## CHANGE ORDER NUMBER (1)

Project: Recreational Trails Connectivity Project - Mission Segment 1

OWNER: Hidalgo County  
 OWNER'S CONTRACT NO: C-25-0170-05-13

**RECREATIONAL TRAILS CONNECTIVITY PROJECT  
PLAN AND PROFILE  
(MISSION SEGMENT 1)**

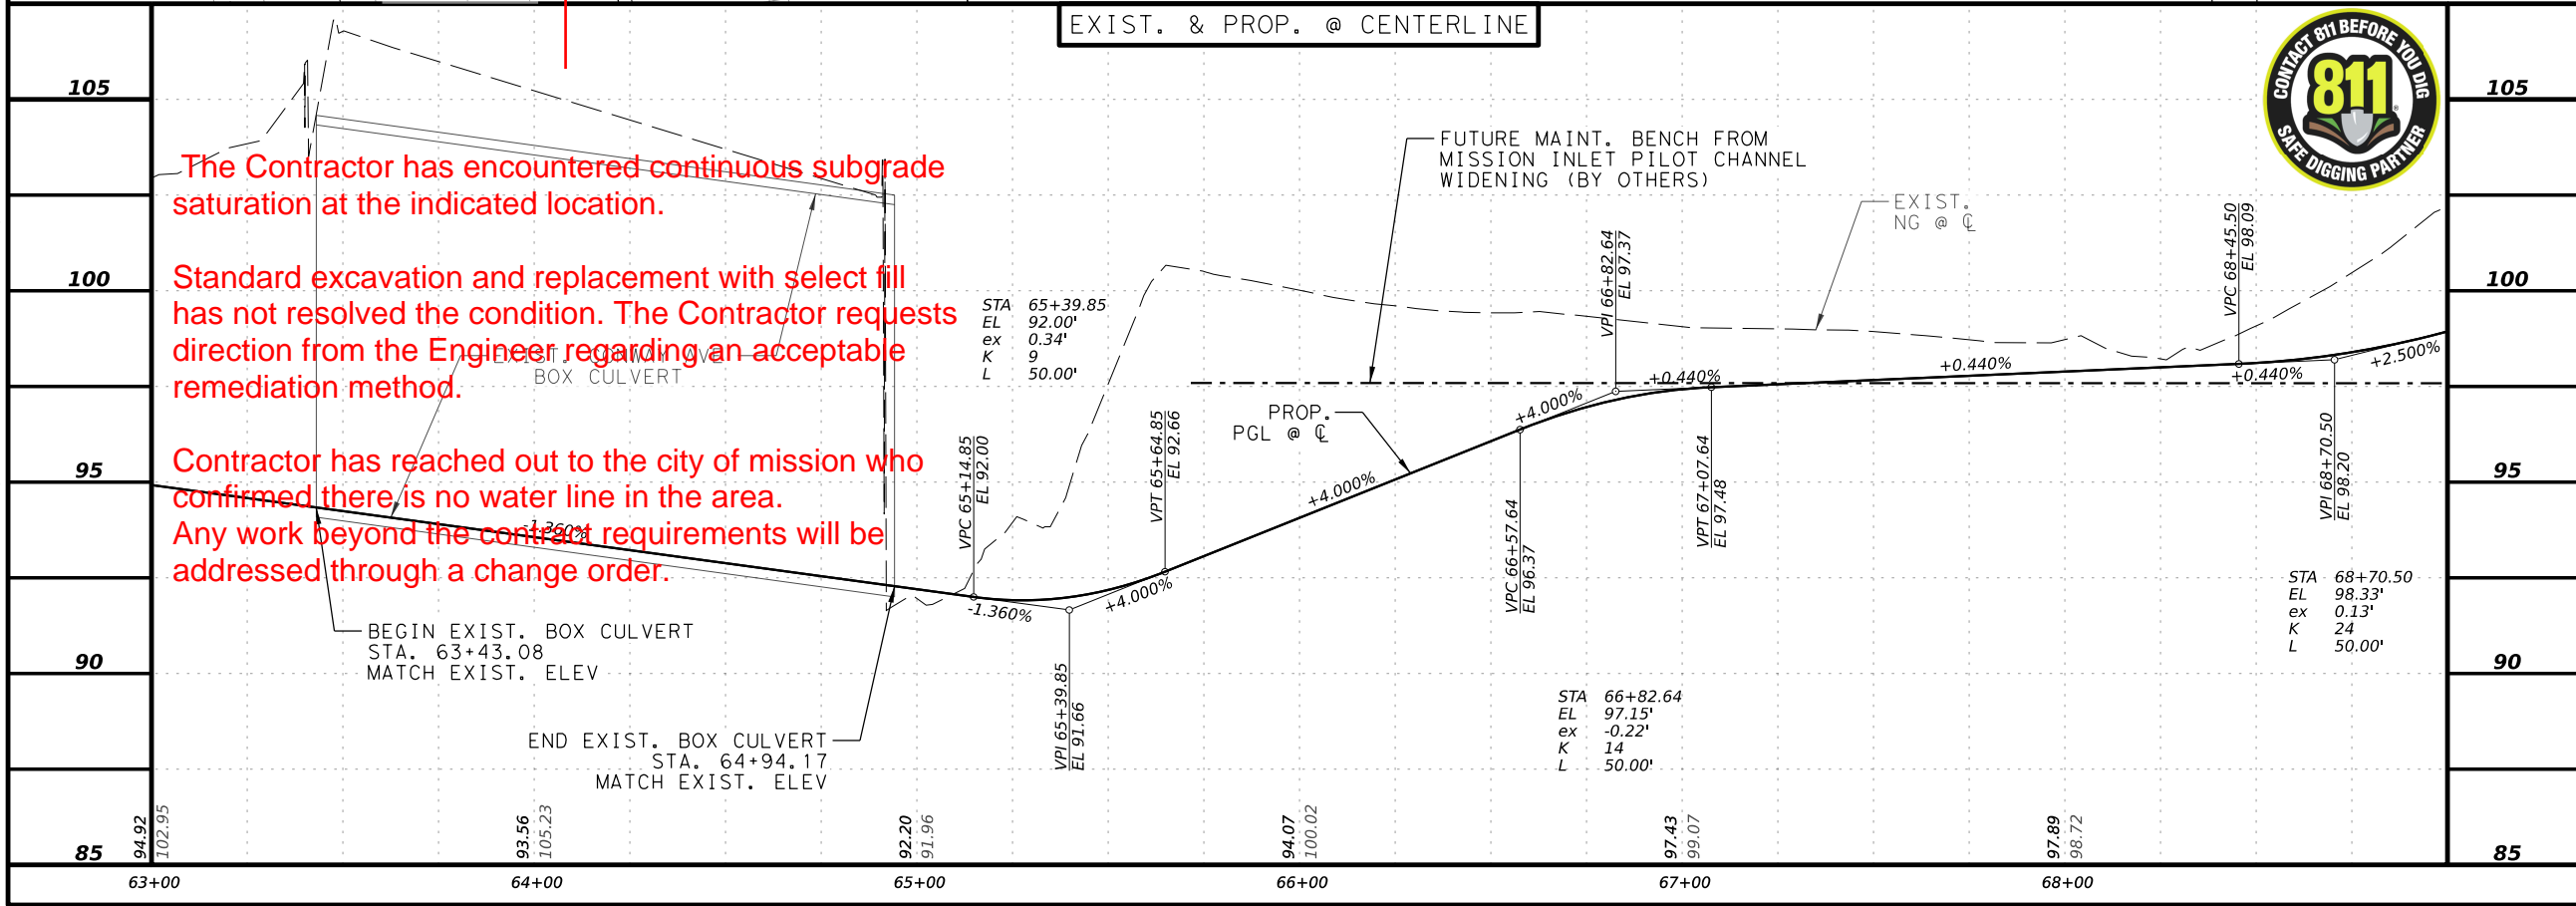
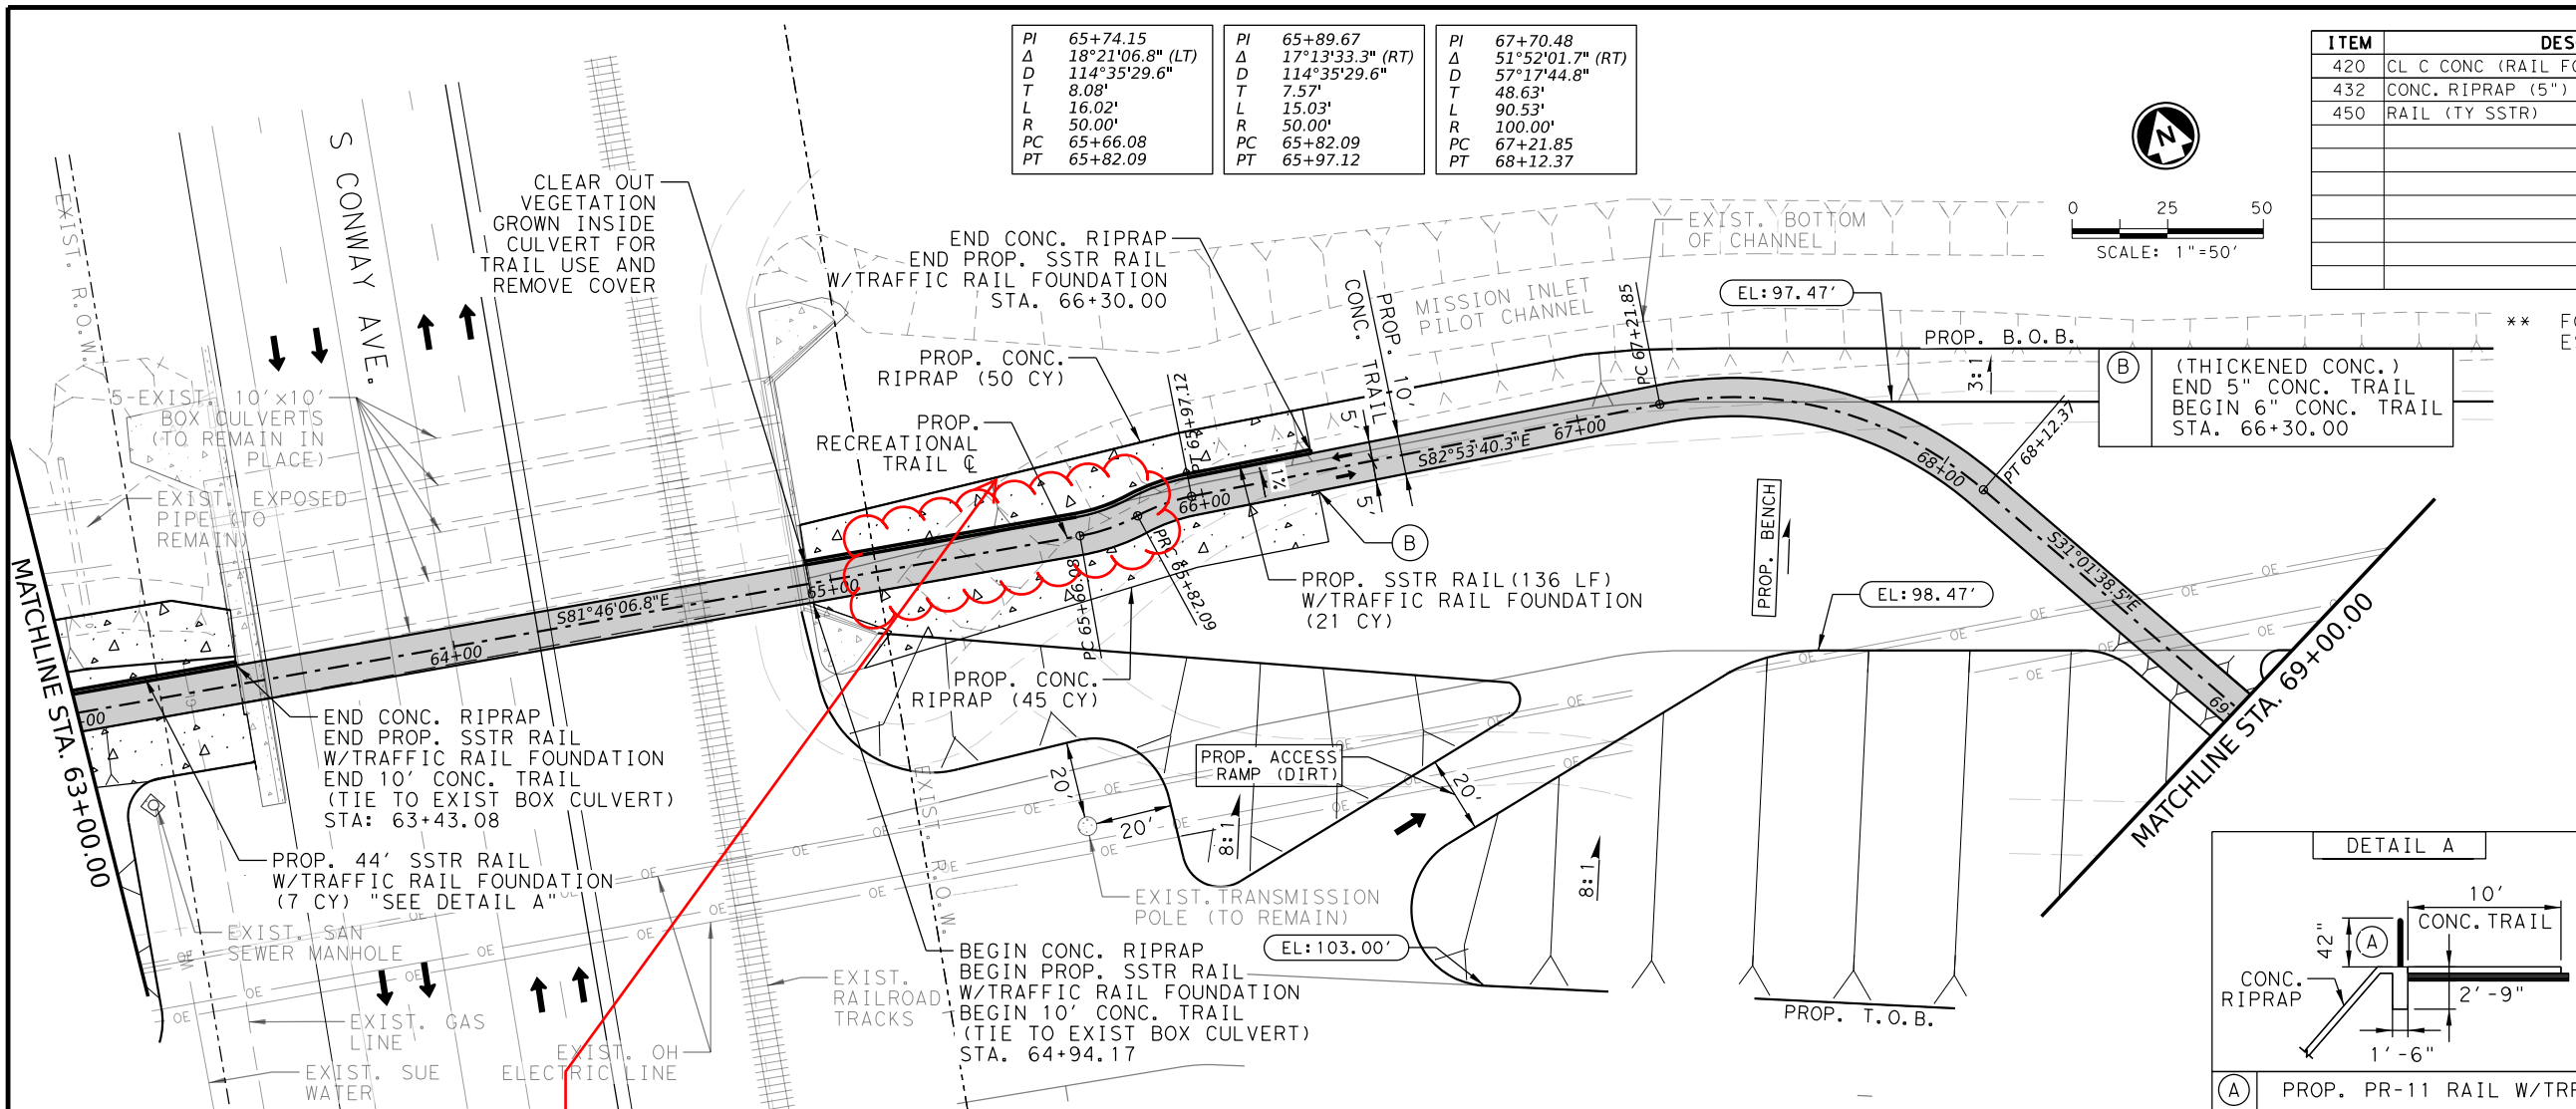
REQUEST / CLARIFICATION REQUIRED	
<p>Per the Engineers response to RFI #7 Contractor was tasked with: under cutting and removing the incompressible material by two (2') feet and replacing it with oversized gravel (2" - 3") bedding. Estimated dimensions are 25' wide X 70' long.</p> <p>Contractor is requesting an additional \$23,000.20 and an Additional 3 Weeks to the contract to complete the additional work as stated above.</p> <p>This includes Excavating Approx. 130 CY and adding a bedding with 2"-3" river rock (Approx 40 Tons) and fabric.</p>	
NAME & TITLE OF REQUESTING PARTY	DATE OF REQUEST
Urbe 21 Design & Construction – Carlos A. Romero - President	3/3/26

REQUEST / CLARIFICATION REQUIRED	
<p>The Contractor has encountered continuous subgrade saturation at the indicated location.</p> <p>Standard excavation and replacement with select fill has not resolved the condition. The Contractor requests direction from the Engineer regarding an acceptable remediation method.</p> <p>Contractor has reached out to the city of mission who confirmed there is no water line in the area. Any work beyond the contract requirements will be addressed through a change order.</p>	
NAME & TITLE OF REQUESTING PARTY	DATE OF REQUEST
Urbe 21 Design & Construction – Carlos A. Romero - President	1/30/2026

The Contractor has encountered continuous subgrade saturation at the indicated location.  
 Standard excavation and replacement with select fill has not resolved the condition. The Contractor requests direction from the Engineer regarding an acceptable remediation method.  
 Contractor has reached out to the city of mission who confirmed there is no water line in the area. Any work beyond the contract requirements will be addressed through a change order.

Description:   
 1. Under cut and remove the incompressible material by two feet (2') and replacing it with oversized gravel (2" - 3") bedding.  
 2.  
 3.  
 4.

RESPONSE	
<p>During our jobsite meeting on Thursday, Jan.8, 2026, the City of Mission Public Works foreman, Mr. Manuel Garza informed us that there was a 12" waterline on the east side of the Conway Ave. and that the previous liming operation on the subgrade had just missed striking this line.</p> <p>Recommendation is to verify if this waterline is broken and take corrective action to fix the leak.</p>	
NAME & TITLE OF RESPONDING PARTY	DATE OF REQUEST
Stanley Ramos	Feb. 2, 2026
